STATE OF NEBRASKA  
DEPARTMENT OF ROADS  
ADDENDUM NO. 1  
AND  
ELECTRONIC BIDDING SYSTEM  
AMENDMENT NO. 1  
PROJECT NO. ELEC-80-1(1031)  
CONTROL NO. 51370  
CALL NO. 510  
I-80. PINE BLUFFS INTERCHANGE  
LETTING DATE: SEPTEMBER 30, 2010

PINE BLUFF INTERCHANGE R.P. 0+48

Add Sheet 44

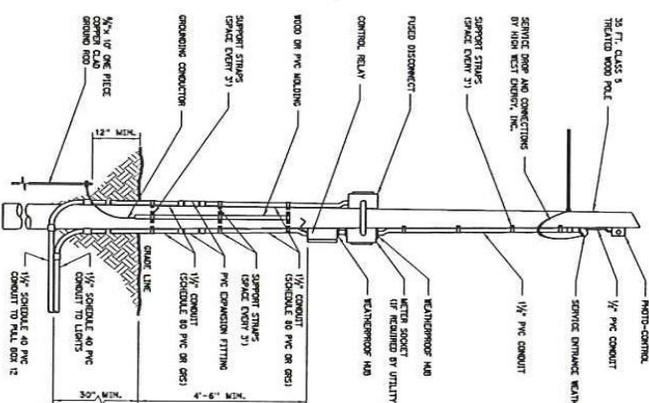
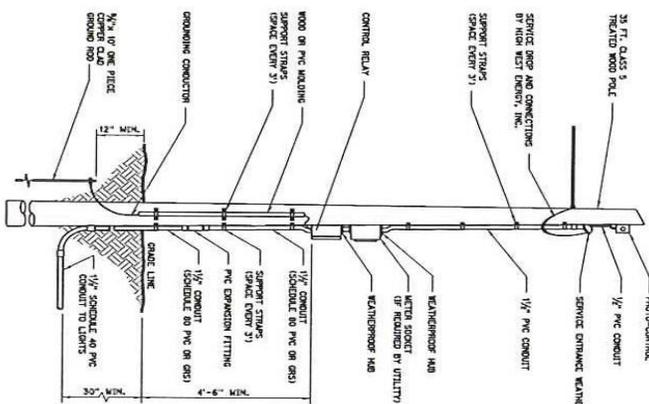
Plan sheets 3 & 4 are void and superseded by added sheets 3A & 4A as depicted on the attached sheets.

TYPICAL OF LIGHTING CONTROL CENTER NO. 1

CONDUIT	RELAY	BREAKERS	COIL
L.C.C. NO. 1	2 REL-100 AMP	2 REL-75 AMP	120 VOLT-40 WZ

TYPICAL OF LIGHTING CONTROL CENTER NO. 2

CONDUIT	RELAY	BREAKERS	COIL
L.C.C. NO. 2	2 REL-100 AMP	2 REL-75 AMP	120 VOLT-40 WZ
